Code Review 2018 Changes to International Codes IECC - RESIDENTIAL - ENERGY TAC

Energy Conservation Code (IECC)-(Residential)

Energy Technical Advisory Committee (TAC)

2018 International Energy Conservation Code - Residential

TABLE R405.5.2(1)

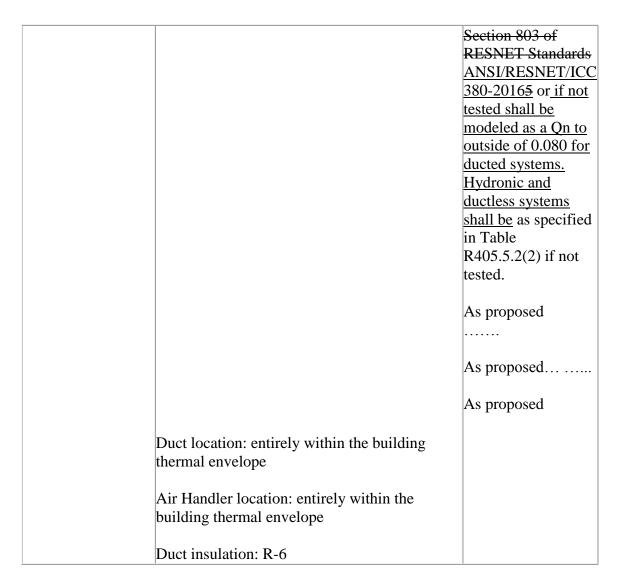
Revise Table R405.5.2 (1) SPECIFICATIONS FOR THE STANDARD REFERENCE AND PROPOSED DESIGNS as follows:

Reason: Currently, the equation used for the reference home in Table R405.5.2(1) assumes continuous operation of the whole house mechanical ventilation system (i.e., 8760 hours/year) and a fixed fan efficacy of 2.2 cfm/W, which is not supported by the fan efficacy requirements in Table R403.6.1. This change will keep the table current by allowing the fan efficacy of the reference home to track with any future changes to the whole house mechanical ventilation fan efficacy requirements in Table R403.6.1.
